GROUP	MODEL
ELE	2025MY K5 (DL3 PE) LXS w/ ISG
NUMBER	DATE
353	August 2024

## TECHNICAL SERVICE BULLETIN

### SERVICE ACTION: LDC GROUND WIRE INSTALLATION (SA583)

This bulletin provides the procedure to install a new, shorter and thicker gauge ground wire on the Low Voltage DC-DC Converter (LDC) harness on certain 2025MY K5 (DL3) LXS w/ Idle Stop Go (ISG) vehicles produced from February 21, 2024 through May 27, 2024. The affected vehicles may experience the AVN head unit blinking and/or rebooting when the engine restarts from a stop with ISG enabled caused by a voltage drop due to an increased length of the ground wire. Follow the procedure outlined in this publication to install a new, shorter and thicker gauge ground wire on the Low Voltage DC-DC Converter (LDC) harness on the applicable vehicle. Before conducting the procedure, verify that the vehicle is included in the list of affected VINs.

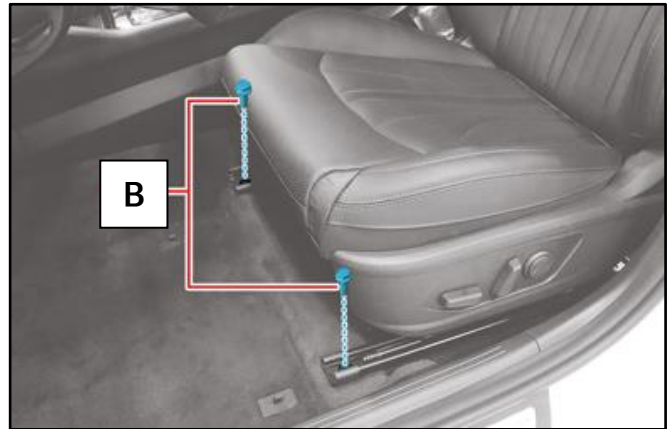
1. Disconnect the negative (-) battery terminal.
2. Remove the left front head rest (A).

3. Loosen the four (4) left front seat retaining bolts (B).

**Tightening torque for Bolts:**  
36.2 - 47.0 lb.ft (49.0 - 63.7 N.m)

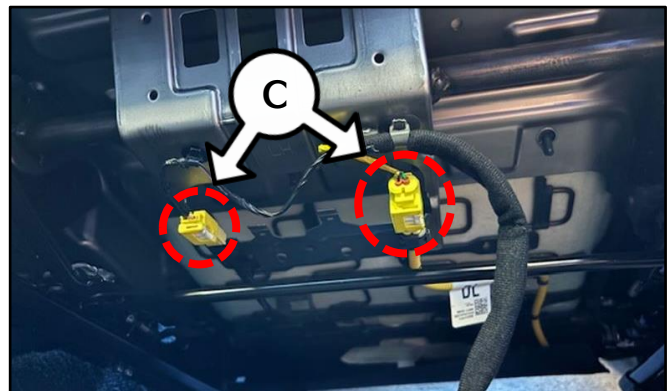
4. Lift the seat and disconnect the two (2) front seat connectors (C).
5. Remove the left front seat assembly.

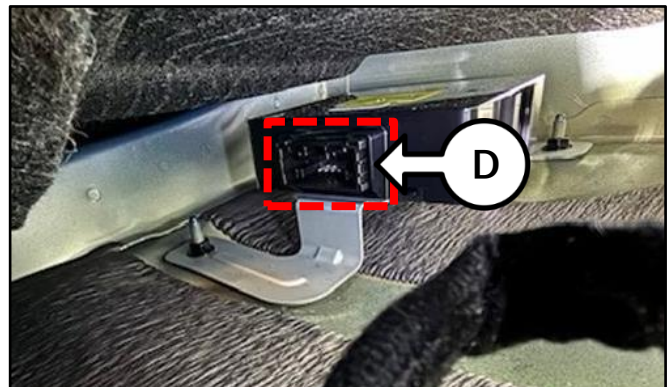
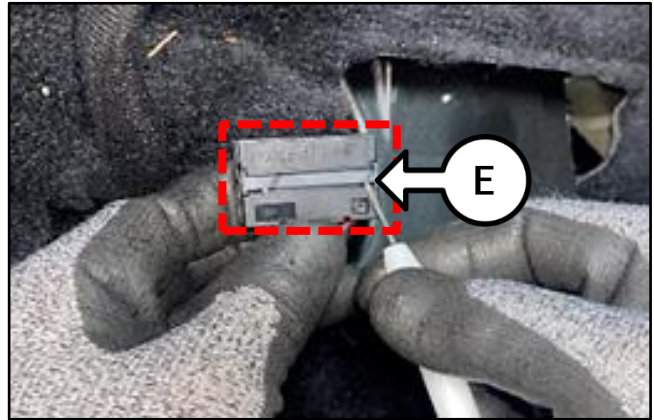
6. Disconnect the LDC connector (D).

**Note: Access the LDC through the access point under the carpet.**

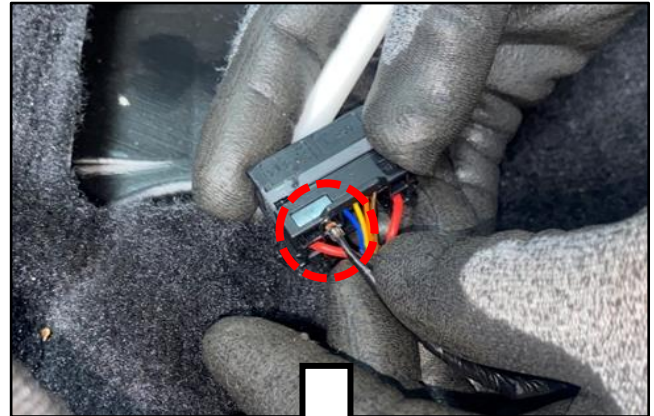
7. Using a pick tool, unlock the LDC connector lock (E).

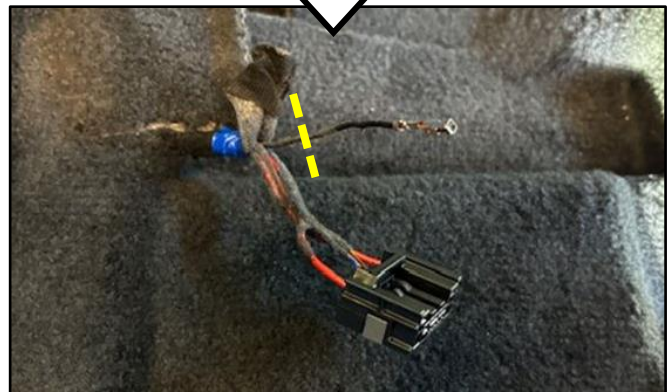
8. Using a pin removal tool, detach the **black wire** (Pin 7) from the LDC connector as shown.

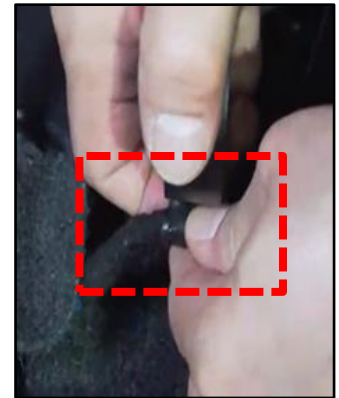
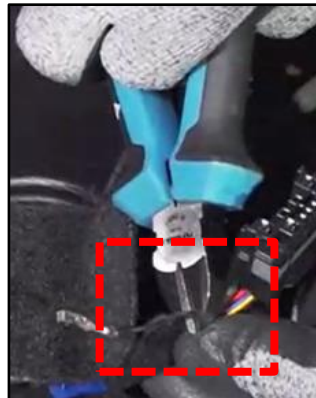
9. Cut the end of the removed **black wire** (Pin 7) where shown.

10. Using electrical tape, tape the wire to the harness, as shown.

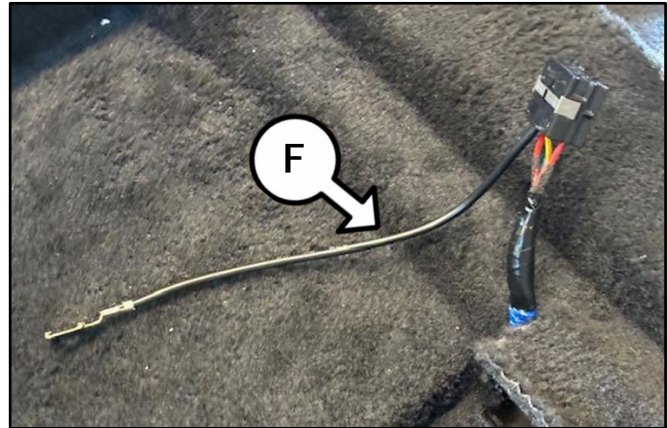
- 9. Insert the new ground wire into the LDC connector (Pin 7) and verify that it is locked in by performing a light pull/push test.

**Ground Wire: PN 915X0 L2000QQK.**

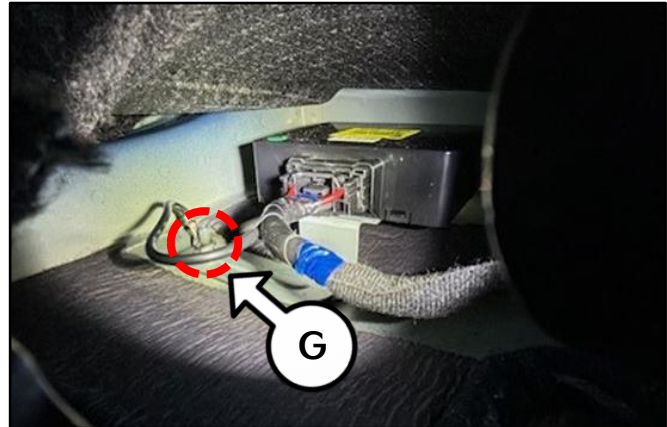
- 10a. Loosen the existing LDC retaining nut (G) and discard the nut (G).

- 10b. Insert the eyelid of the new ground wire over the threads and secure the wire by installing a 'new' nut as shown.

**Nut: PN 95917 3S000QQK.**

**Note: Do not reuse the old/removed nut (G).**
